Proposal for the 01 series of amendments to UN Regulation No. UN Regulation No. 153 (Fuel system integrity and electric power train safety at rear-end collision). Amendments to ECE/TRANS/WP.29/GRSP/2024/12/Rev.1.

Submitted by the expert from France *

The text reproduced below was prepared by the expert from France. The proposal aims to update the requirements on post-crash electrical safety of UN Regulation No. 153. The modifications to the current text of the UN Regulation are marked in bold for new or strikethrough for deleted characters.

Model A

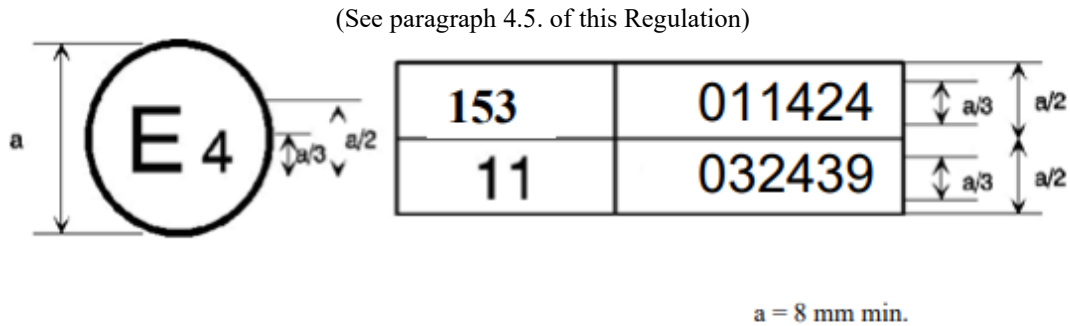
The above approval mark affixed to a vehicle shows that the vehicle type concerned has, with regard to the protection of the occupants in the event of a frontal collision, been approved in the Netherlands (E 4) pursuant to UN Regulation No. 153 under approval number 001424. The approval number indicates that the approval was granted in accordance with the requirements of UN Regulation No. 153 **as amended by the 01 series of amendments.**

The first two digits of the approval numbers indicate that, at the dates when the respective approvals were granted, UN Regulation No. 153 **incorporated the 01 series of amendments** and UN Regulation No. 11 incorporated the 03 series of amendments"

Figure 3
Jointed Test Finger

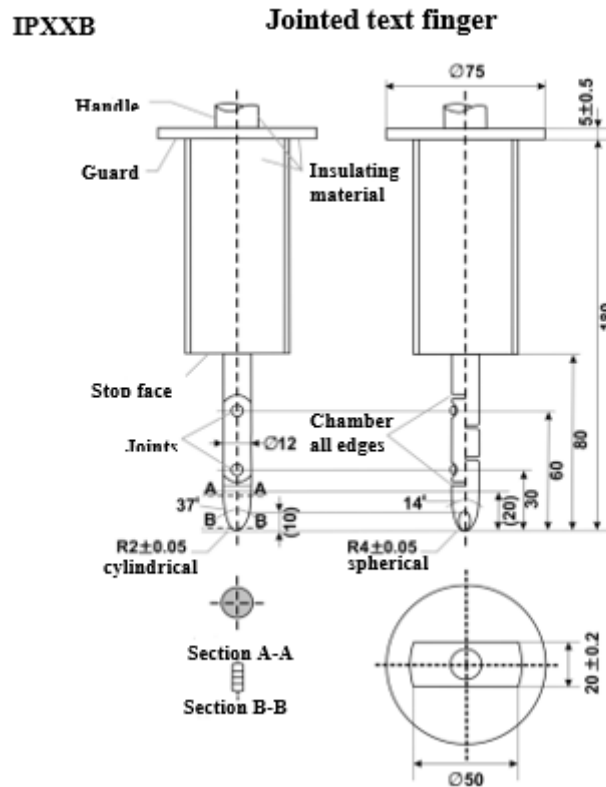
- (a) \ominus on angles: $+0/-10$ seconds $0^{\circ}0'0''/0^{\circ}0'10''$;
- (b) \ominus on linear dimensions:
 - (i) **up to** ≤ 25 mm: $+0/-0.05$ mm;
 - (ii) **over** > 25 mm: ± 0.2 mm.
